SERVICE BULLETIN

N° 101-29

SN CENTRAIR GLIDERS
101 all types "Pégase"

SUBJECT:VERIFICATION OF SETTING OF RUDDER BAR LOCKING
ADJUSTMENT TUBE**VALIDITY:**

Rudder bar locking
adjustment tube

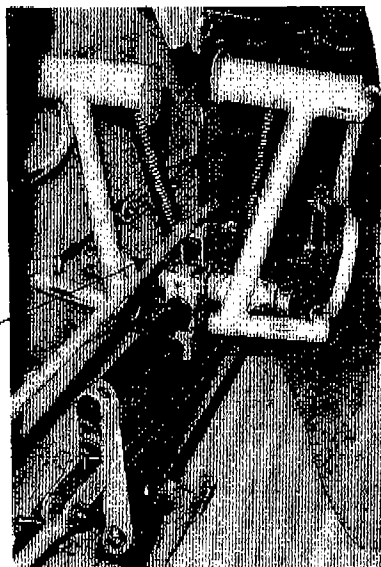
The adjustment system of the rudder bar
comprises a tube attached to a tipper with
which the rudder bar can be unlocked and
adjusted remotely in relation to the pilot's
seat back. (See photo no. 1)

This locking tube was reinforced in 1984 to avoid any concerns over operation. Gliders
manufactured prior to this adaptation have not been systematically retrofitted.

Photo no. 2

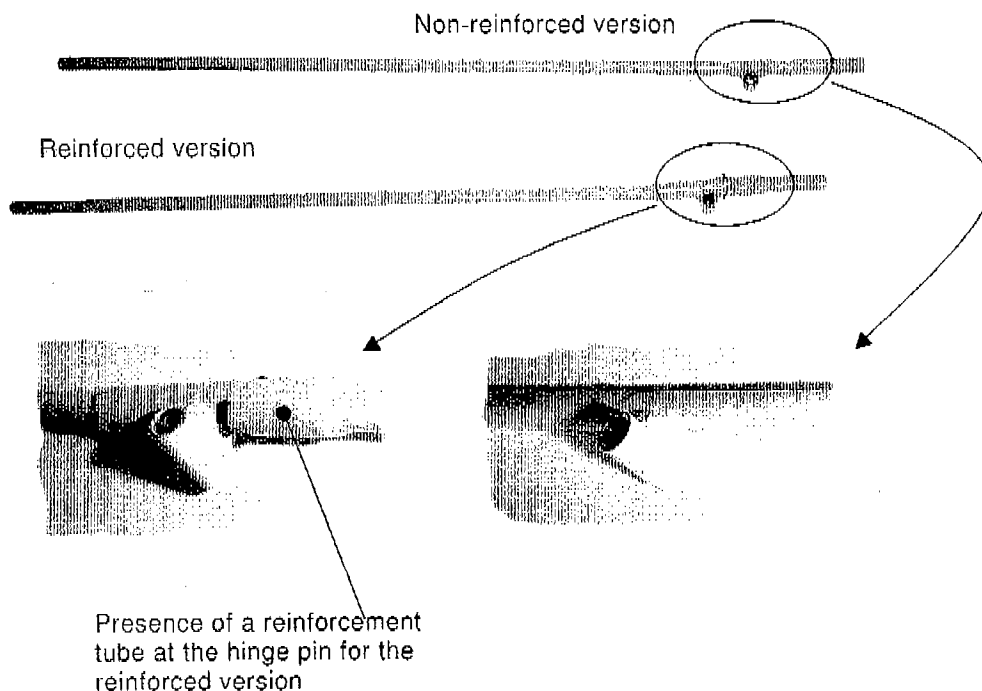
The differences between the 2 versions are shown in photo no. 2 below.

Having recently been informed of one of the old versions of this locking tube breaking, it is therefore confirmed that the reinforcement of this part was justified and the systematic replacement of non-reinforced parts is now necessary.

It is therefore requested, within 1 month, that you check the adjustment tube version installed in your glider (visual examination without dismantling the part from the glider).

If you see that you have the reinforced tube (see photo no. 2), you do not need to take any further action.

If, however, you see that you have the non-reinforced version (see photo no. 2), you are requested to replace it with a part ref. \$Y186A before the next annual visit.

If the locking tube is damaged, it must be replaced before the next flight.
